# Palmdale Regional Groundwater Recharge and Recovery Project

Final Environmental Impact Report

SCH No. 2015061054

June 2016

## Proposed Project and Local Jurisdictional Boundaries

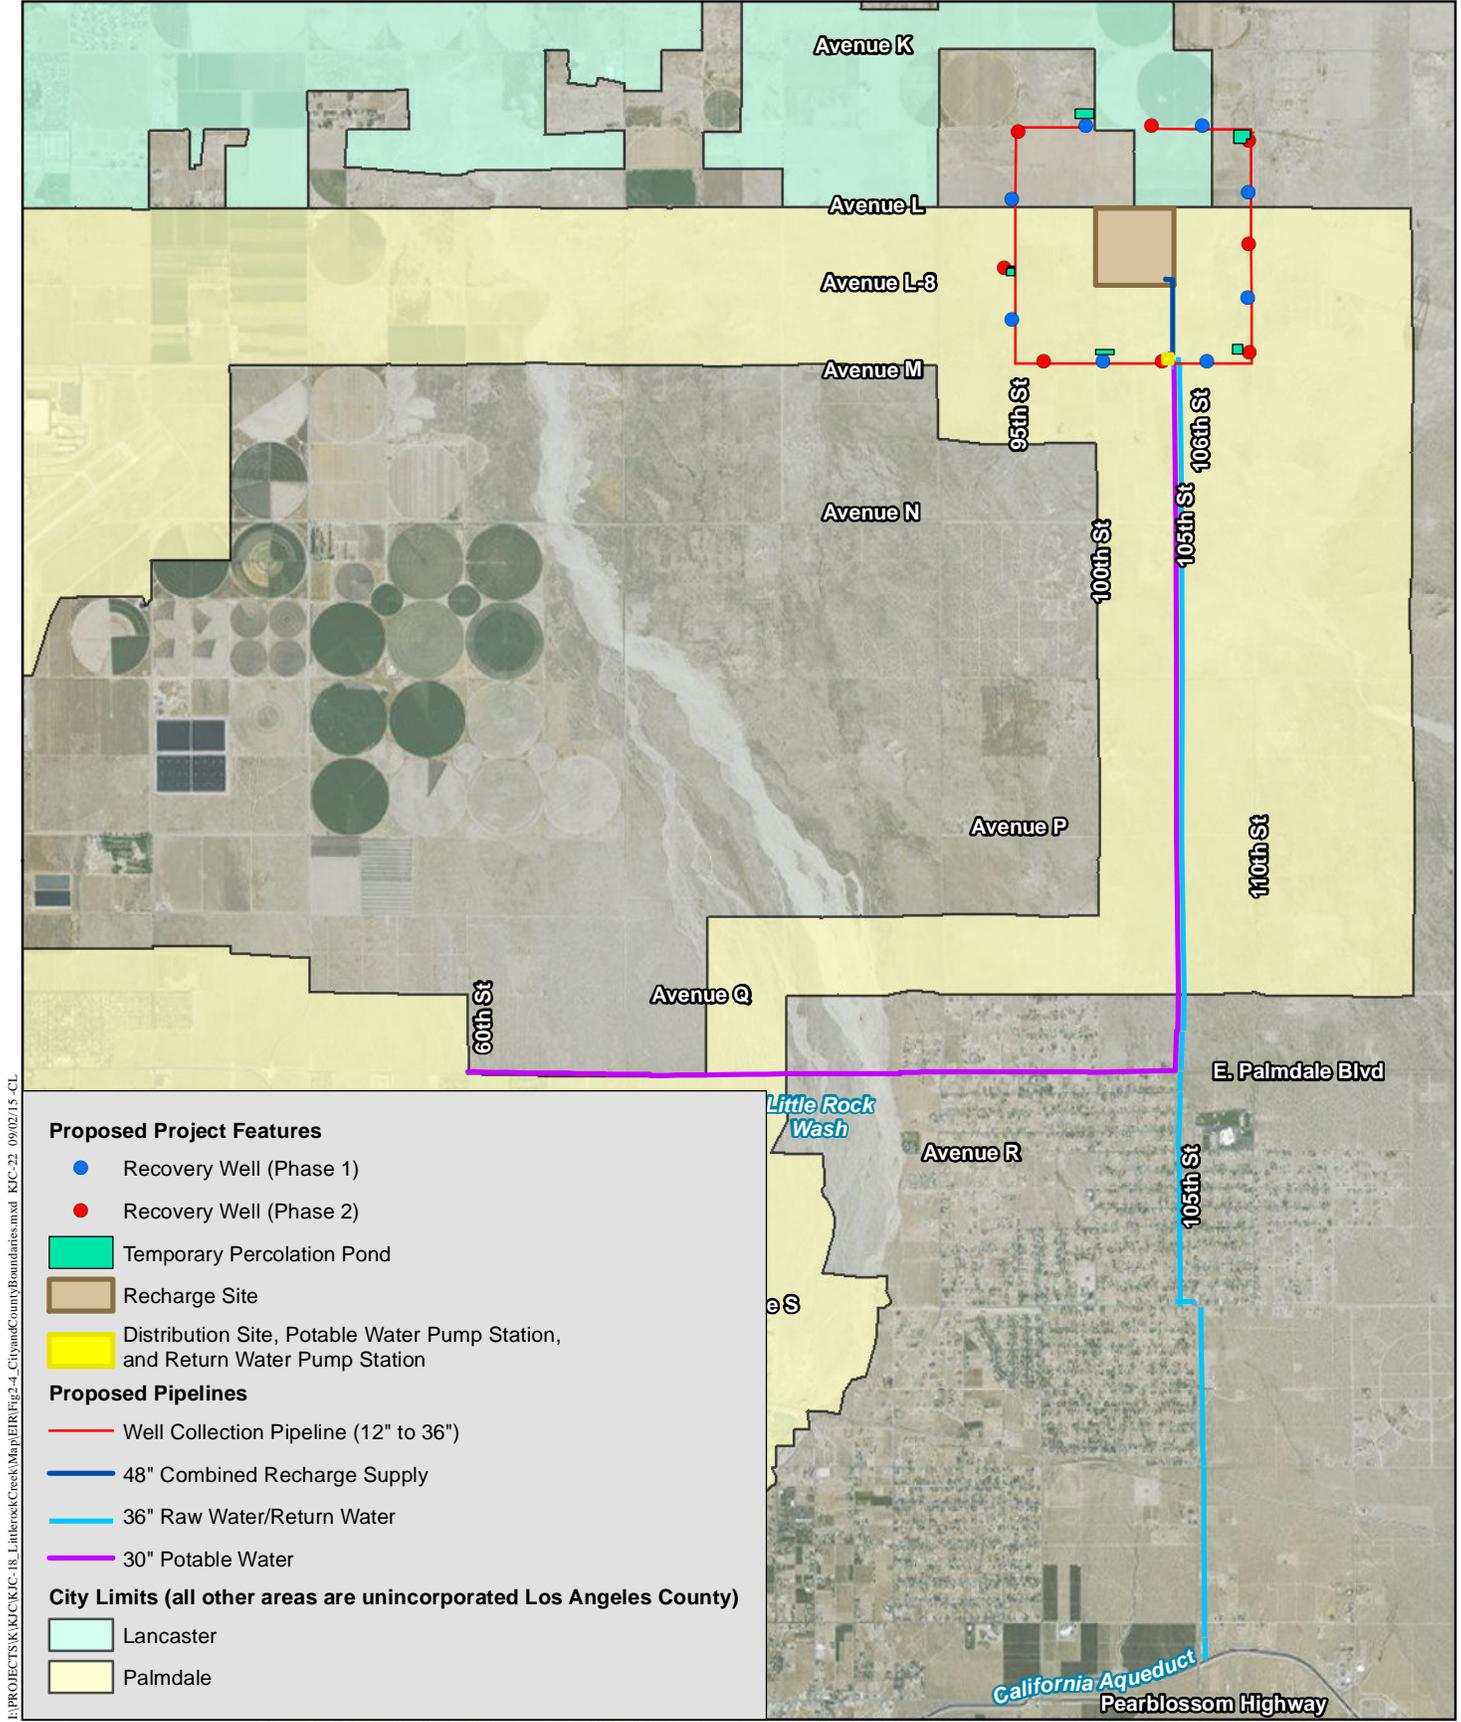
The Department has broad regulatory authority over impacts to waters of the state including episodic drainages and their floodplains. Due to the linear nature of the Project crossing Little Rock Wash and the Project's location within a designated floodplain the Department recommends that PWD provide written notification to the Department pursuant to section 1600 et seq. of the Fish and Game Code. Based on this notification and other information, the Department determines whether a Lake and Streambed Alteration Agreement (LSA) with the applicant is required prior to conducting the proposed activities. The Department's issuance of a LSA for a project that is subject to CEQA will require CEQA compliance actions by the Department as a Responsible Agency. As a Responsible Agency, the Department may consider the Negative Declaration or Environmental Impact Report of the local jurisdiction (Lead Agency) for the project. To minimize additional requirements by the Department pursuant to section 1600 et seq. and/or under CEQA, the document should fully identify the potential impacts to the stream or riparian resources and provide adequate avoidance, mitigation, monitoring and reporting commitments for issuance of the LSA. A notification package for a LSA may be obtained by accessing the Department's web site at [www.wildlife.ca.gov/habcon/1600](http://www.wildlife.ca.gov/habcon/1600).

Figure 2-4 of the Draft EIR correctly shows that the 30-inch Potable Water pipeline within Palmdale Boulevard does cross Little Rock Wash. However, as discussed in the Draft EIR, the 30-inch Potable Water pipeline would be located entirely within the maintained road right-of-way. Likewise, construction activities would occur entirely within the maintained road right-of-way and would not encroach into areas of the wash. Standard construction best management practices would be implemented during pipeline placement in Palmdale Boulevard, including the portion that crosses Little Rock Wash. Construction activities and pipeline placement would occur entirely within the maintained portion

- D17 cont. of Palmdale Boulevard, and best management practices would be implemented during construction to ensure no runoff or contaminants would impact the wash. As such, no encroachment into or impacts to jurisdictional areas would occur. Minor additional text has been added to Section 3.2, Biological Resources, to further clarify that no jurisdictional impacts would occur.
- D18 Refer to response D17. As discussed, the Project would not result in impacts to jurisdictional areas.
- D19 The Department's concurrence with the burrowing owl mitigation measure is acknowledged.
